Project: Cimarron Service Center
2283 Waynoka Rd.
El Paso County, Colorado

SP1
SITE PLAN
Sheet 1 of 1

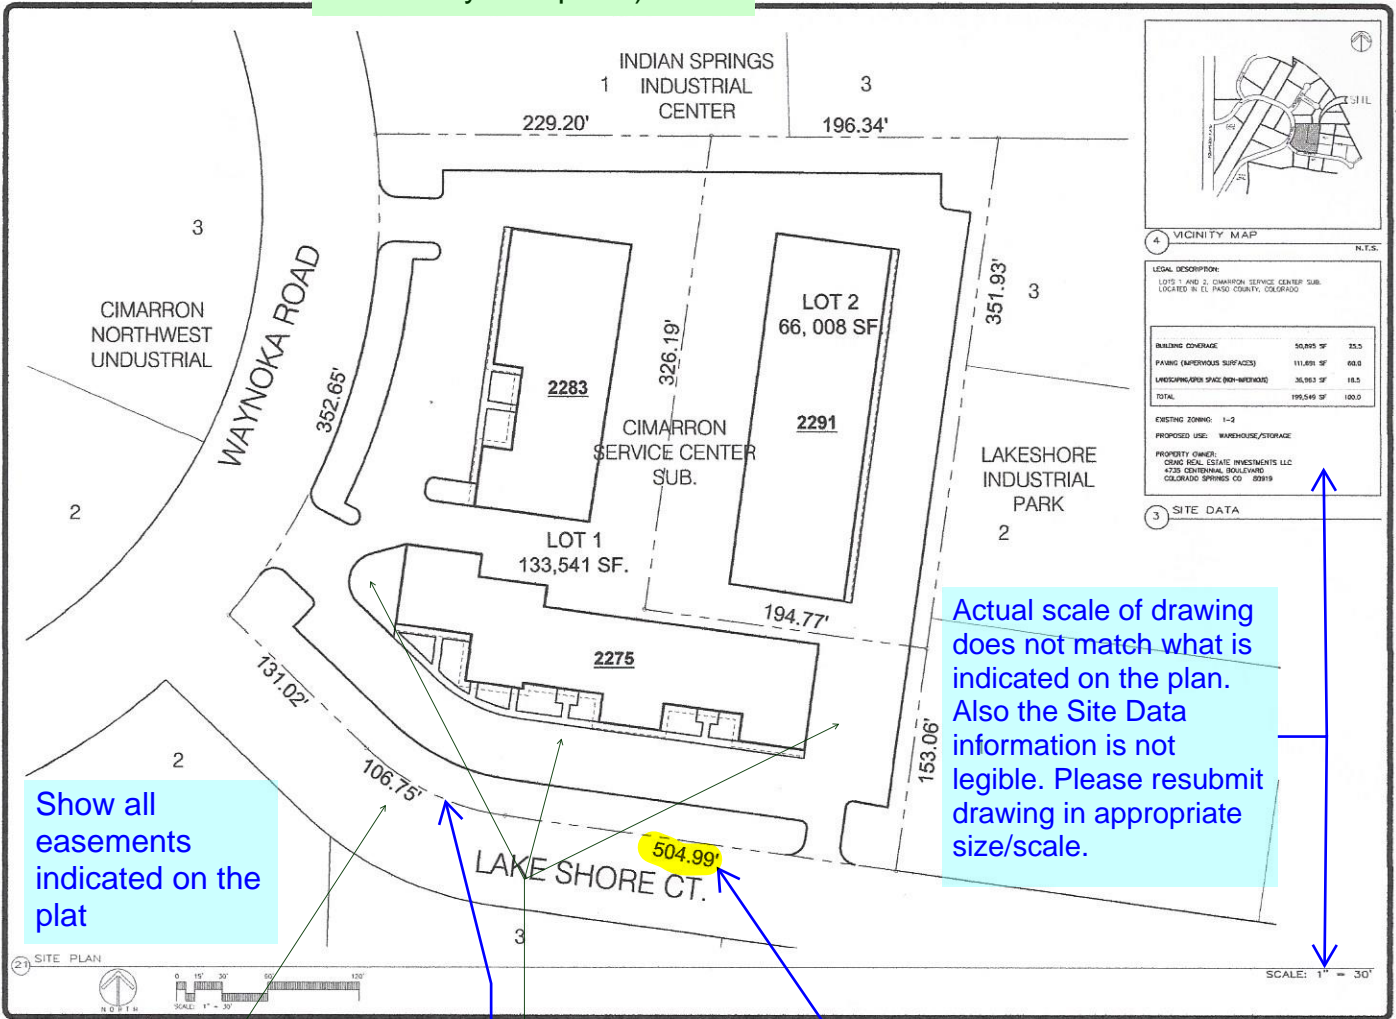
Include the units where the vehicle repair garages will take place. (attach the tenant map and mark the building where they take place).

Show all easements indicated on the plat

Actual scale of drawing does not match what is indicated on the plan. Also the Site Data information is not legible. Please resubmit drawing in appropriate size/scale.

Add PCD File No. AL1826

Label property lines

Show existing setbacks.

Plat No. 8833 indicates this length as 270'. Revise accordingly.

Show all easements indicated in the title commitment.
